TECHNICAL COMMUNICATION No. 02-200317 April 2003

Subject: engine oil level**Model: Breva V750 i.e.****Frames involved: all**

Subject: oil in the air box

Model: Nevada 750

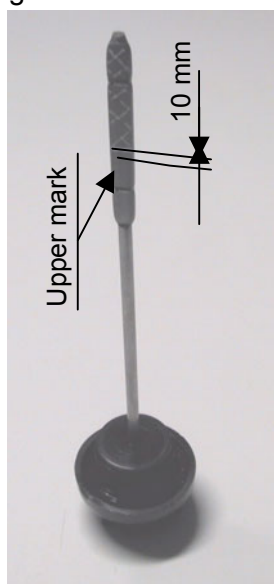
Fault experienced on vehicle: excessive quantity of oil extracted from the oil recover circuit.

Main cause: excessive quantity of engine oil.

An excessive quantity of engine oil can cause an increase in the oil extracted by the crankcase gas recover circuit. In exceptional cases an oil present in the transparent recovery tube, which extends from the filter housing to the rear joint of the right half cradle, type of anomaly can be experienced.

The checking operation can be easily carried out by using the oil filler cap dipstick. The correct quantity of oil wets the dipstick up to around 10-11 mm under the maximum level reference mark. The highlighted part in the photo shows the section of dipstick which must be wet. The check must be carried out with the engine warmed up, after around 20 minutes that it is running.

Technical solution: check and restore correct engine oil quantity (1.8 kg).

Check the correct engine oil level to avoid this inconvenience.

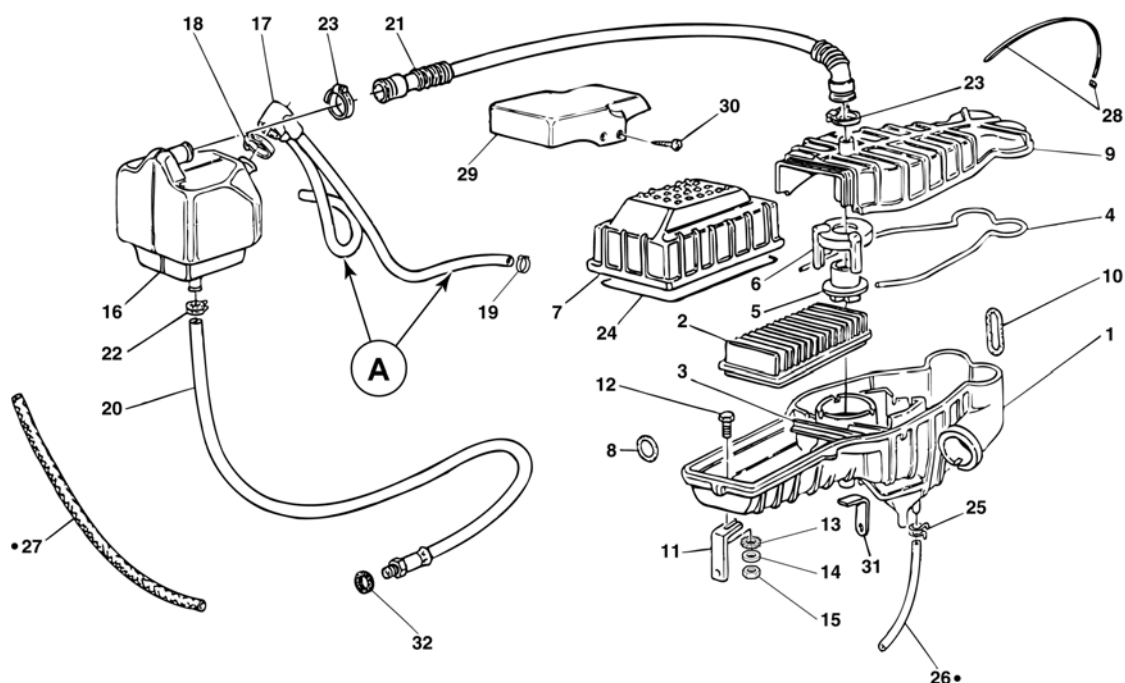
too much oil in the air box

The presence of oil in the decanter box and -following oil vapours circuit- in the air box has two main causes:

- too high oil level
- high pressure of the gases inside the crankcase

- Check that the two hoses (A) taking the oil vapours from the head covers to the decanter are not squashed due to their flexibility; if so, change them with more rigid hoses.
